Subject: **Bid No. 8193-M4 Sewer Line Repairs (CIPP) / WPS**

ADDENDUM NO. 2

Burncoat Elementary Exterior Plan:

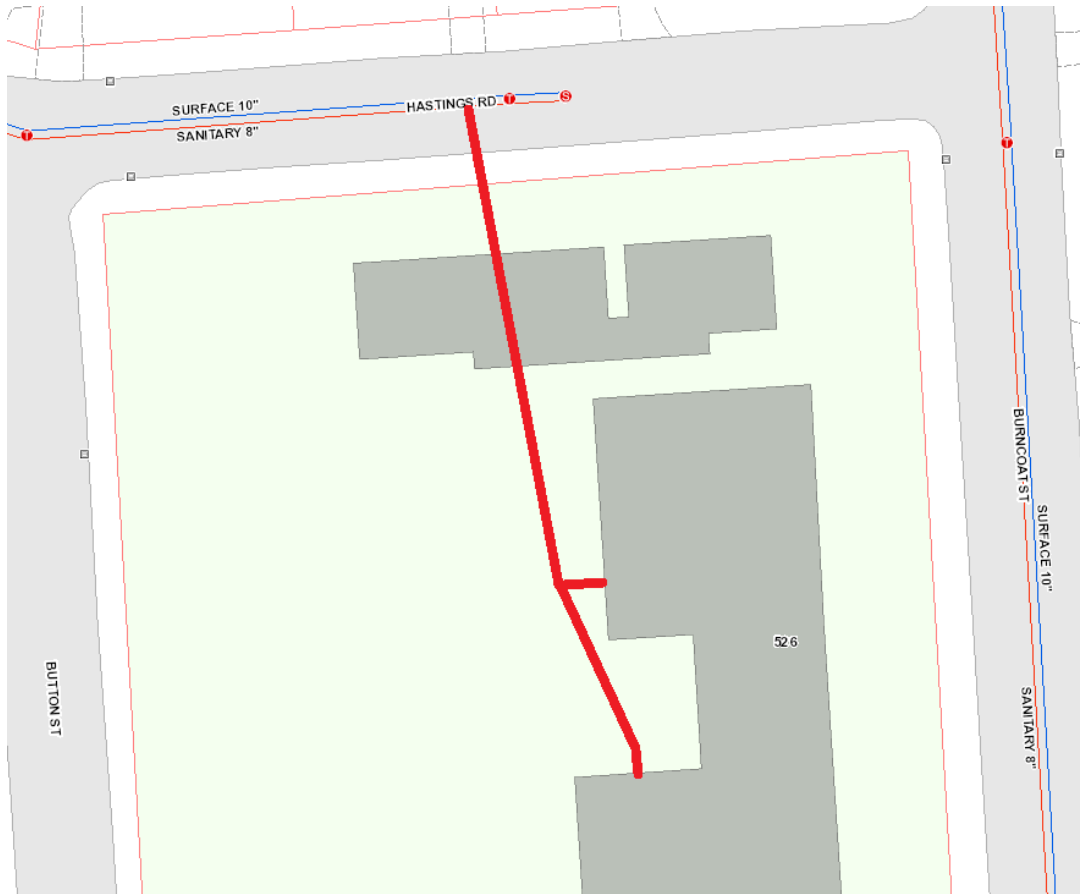
- What is the size (diameter) of each cleanout and is each cleanout fully accessible from the surface level? **At Burncoat Elementary, the cleanout is accessible from the at-grade parking lot and also the interior access pit. At Durkin Admin Bldg., the lateral access is via two interior pits inside the basement level of the building.**

- Does each lateral terminate at a connection to a sewer main or does each lateral discharge and end directly in an existing sewer manhole? **At Burncoat Elementary, the lateral terminates directly into a sanitary main on Hastings St, not a manhole; the DPW field verified this on 5/24/2024. At Durkin Admin Bldg., the access is via two interior pits inside the basement level of the building. The Northern sanitary line at this location terminates into a manhole, while the southern line connects directly into the sanitary main.**

- **At all three pit locations (one at Burncoat, two at Durkin Admin Bldg), the awarded vendor shall remove the existing "house/building traps" and replace them with code compatible cleanouts.**
